Access Compliance Report

(Curb Ramps)

Intersection ID: 17341	Main Street: AUTUMN_RAIN_LN	Cross Street: SHADOW_ELM_DR	Location:	NE
ADA ID: 6DB6E790BD68	Ramp Type: PerpDiag	Initial Pass/Fail: Fail	Overall Compliance: No	Severity Score: 25
Codes/Mitigation Info/Possible Solution		Field Measurements/Component Compliance

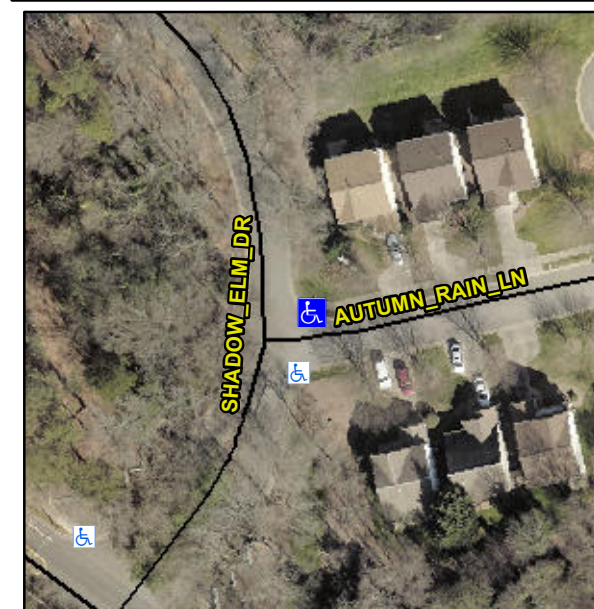
Not Found, R304.5.3

Compliance	Description	Data	Compliance	Description	Data
N/A	Ramp Length (in)	96.0	Yes	Ramp Slope (%)	5.4
Yes	Ramp Width (in)	60.0	No	Ramp XSlope (%)	7.3
N/A	Flare Type LT	N/A	N/A	Flare Type RT	N/A
N/A	Flare Slope LT (%)	N/A	N/A	Flare Slope RT (%)	N/A
N/A	Flare Traversable LT?	N/A	N/A	Flare Traversable RT?	N/A
N/A	Landing Length (in)	N/A	N/A	DWS Provided?	N/A
N/A	Landing Width (in)	N/A	N/A	DWS Contrast?	N/A
N/A	Landing Slope (%)	N/A	N/A	DWS Length (in)	N/A
N/A	Landing X Slope (%)	N/A	N/A	DWS Full Width?	N/A
N/A	Landing Curb? (Y/N)	N/A	N/A	DWS Offset (in)	N/A
N/A	Shared Landing?	N/A			
N/A	Gutter Ponding?	N/A	N/A	Gutter Slope (%)	N/A
N/A	Gutter Lip Ht (in)	N/A	N/A	Gutter X Slope (%)	N/A
N/A	Painted X Walk1?	No	N/A	Painted X Walk2?	No
	X Walk 1 Direction	To W		X Walk 2 Direction	To SW
N/A	X Walk 1 Width (in)	N/A	N/A	X Walk 2 Width (in)	N/A
	X Walk 1 Slope (%)	4.6		X Walk 2 Slope (%)	1.0
	X Walk 1 X Slope (%)	0.7		X Walk 2 X Slope (%)	4.9

Remove & Replace Curb Ramp With Two New Directional Ramps or Equivalent.
